Technical Evaluation of Report NUS - 4396 "The Effects of Tornadoes on the
Availability of the Auxiliary Feedwater System at H. B. Robinson Unit 2"
(Second Revision, August 1983).

1. INTRODUCTION

The objective of this evaluation is to assess the validity and the degree of conservatism of the assumptions, data, and mathematical approach used in the Report NUS - 4396^a to estimate the effect of extreme winds on the availability of the Auxiliary Feedwater System at H. B. Robinson Unit 2.

FIG. 1

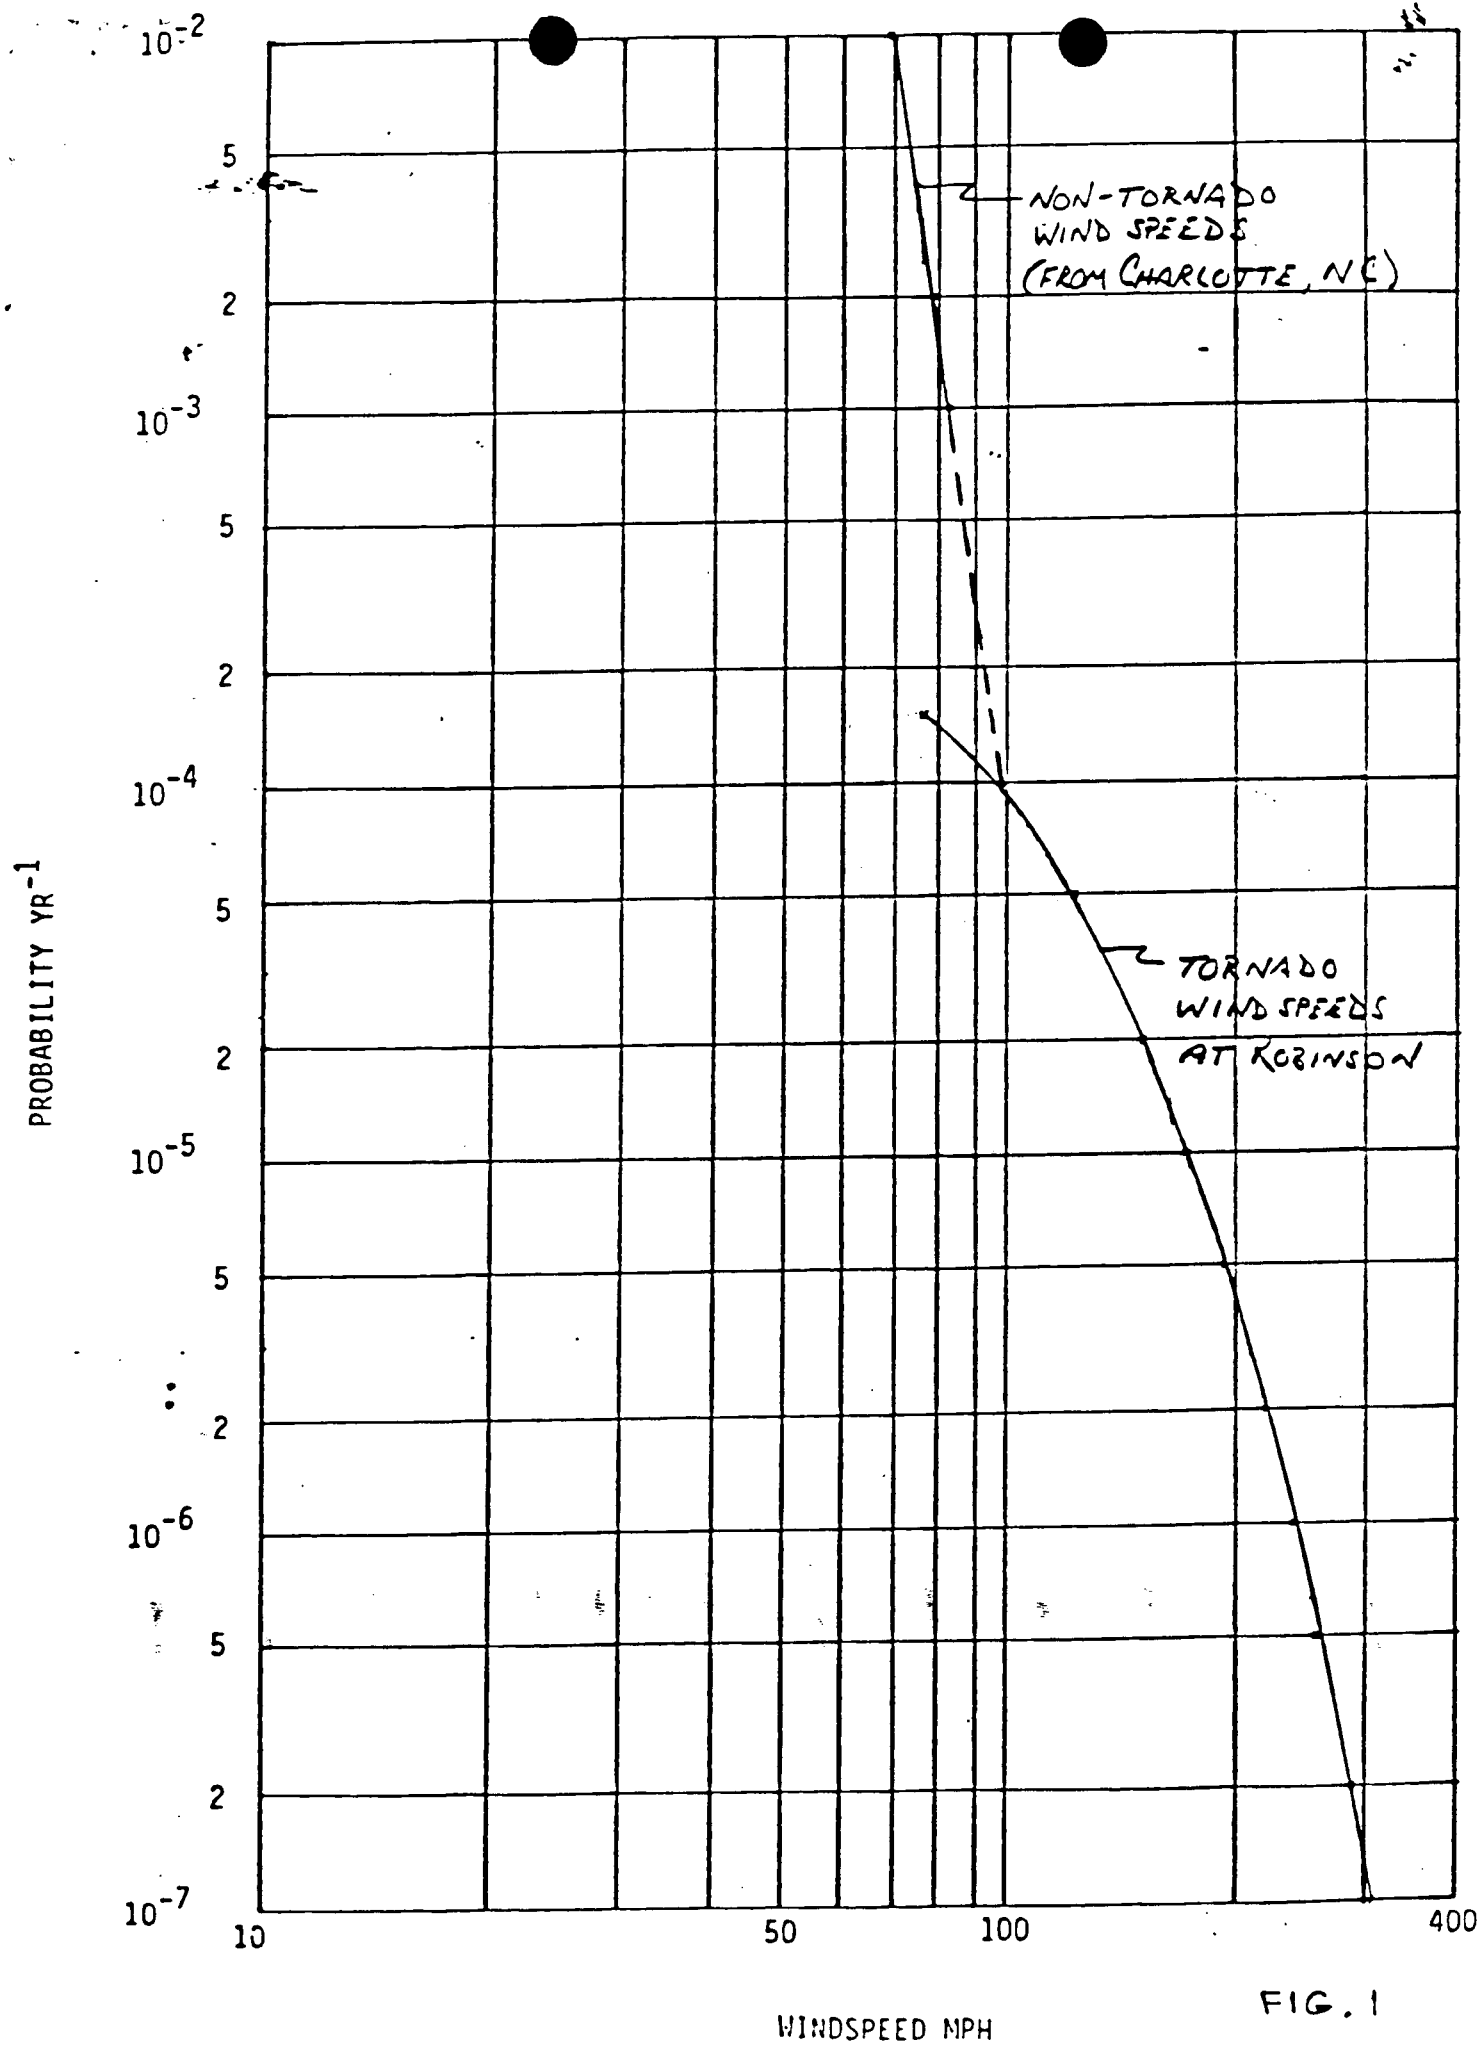
According to assumption 1, Sect. 3, $P(O) = P(W)$. According to the Report, $P(W) = 1.9 \times 10^{-4}$ per year (due only to tornadoes). However, according to memorandum Docket No. 50-261 from William P. Gamill to Olan D. Parr, dated June 12, 1982 on Tornado and Extreme Wind Frequencies for H. B. Robinson Plant (TAC # 49223), winds in excess of 73 mph due to non-tornadic phenomena are more likely than those due to tornadoes, so that $P(W) \approx 3 \times 10^{-3}$ per year (see Fig. 1). Since, according to assumption ⁵X, Sect. 3, $P(E) = 10^{-3}$, it follows from Eq. 1 that

Equation 3a holds because the occurrence of the extreme winds that result in the failure of the Condensate Storage Tank also causes the loss of offsite power. Equation 3b and 3c follow from assumptions 12 and 3, Sect. 3, respectively. According to the Report, $P(F_3) = 1.55 \times 10^{-6}$ per year. However, according to Fig. 1, $P(F_3) \approx 10^{-5}$ per year. From Eq. 3c and assumption 4 it then follows that

The assumptions listed in the Report (see Sect. 3 of this evaluation) are acceptable from the point of view of their conservatism, as is the assumption that failure of the Service Water System Motors entails failure of the Auxiliary Feedwater System even if the Condensate Storage Tank were available. The mathematical approach is also acceptable. However, the reviewer feels that the data are incomplete in that nontornadoic wind speed information is not included. Indeed, probabilities $P(O)$ and $P(W)$ are determined by the occurrence of nontornadoic winds (see Fig. 1).

This is about one order of magnitude higher than the probability of failure estimated in the Report.

$$\begin{aligned} P_f &\approx P(O,E) + P(O,A) + P(O,C,\bar{S},M) \\ &\quad + P(O,S) \\ &\approx 3 \times 10^{-6} + 3 \times 10^{-7} + \frac{5}{6} 10^{-7} + 10^{-5} \\ &\approx 1.34 \times 10^{-5} \text{ per year} \end{aligned}$$
